Subject: 2005-2006 Frontier King Cab Fuel Filler Cap Voluntary Safety Recall Campaign

DRAFT
FRONTIER FUEL CAP TETHER
INTERIM REPAIR INSTRUCTION

VEHICLE AFFECTED:	2005 - 2006	NISSAN	FRONTIER / KING CAB	DATE: 03/23/2006
Vehicle built between:	1N6*D06**5C400002 - 466254 1N6*D06**6C400001 - 435956			
	ATTN: SERVICE MANAGER		DLR: ALL	
Description:	REPLACE FUEL CAP TETHER

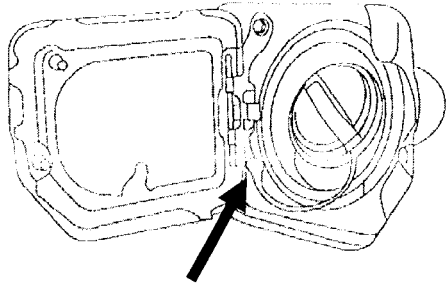
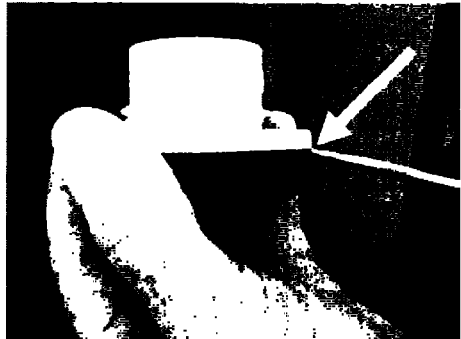
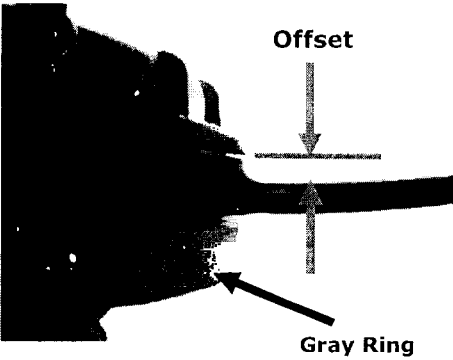
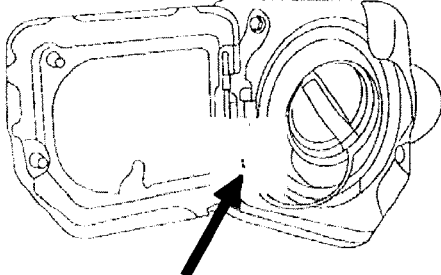
STEP	INSTRUCTION	NEXT	ILLUSTRATION / REFERENCE
1	<ul style="list-style-type: none">Open fuel filler door.Remove fuel filler cap (turn counterclockwise).	GO TO STEP 2	
2	<ul style="list-style-type: none">Remove the tether anchor plastic rivet from body panel.	GO TO STEP 3	
3	<ul style="list-style-type: none">Remove gray plastic retainer ring from fuel filler cap. <p>Note: Use a pocket screwdriver and pry between the black tether ring and the gray retainer ring.</p> <ul style="list-style-type: none">Remove fuel filler cap tether from fuel filler cap.	GO TO STEP 4

<p>4</p>	<ul style="list-style-type: none"> • Install new tether onto fuel filler cap as shown. <p>Note: The tether offset on the black ring must be installed towards the gray retainer ring.</p>	<p>GO TO STEP 5</p>	
<p>5</p>	<ul style="list-style-type: none"> • Reinstall gray plastic retainer ring onto fuel filler cap. • Snaps gray retainer ring into place until fully seated on fuel filler cap. 	<p>GO TO STEP 6</p>	
<p>6</p>	<ul style="list-style-type: none"> • Reinstall and tighten fuel filler cap first (turn clockwise). • Install new plastic rivet through tether anchor hole and into body panel. <p>Note: The tether must not be twisted when installing rivet into body panel.</p> <ul style="list-style-type: none"> • Close fuel filler door. 	<p>END</p>

DESCRIPTION	PART NUMBER	QUANTITY
Ret-Fuel Cap, Mtg	17429-ZP00A	1
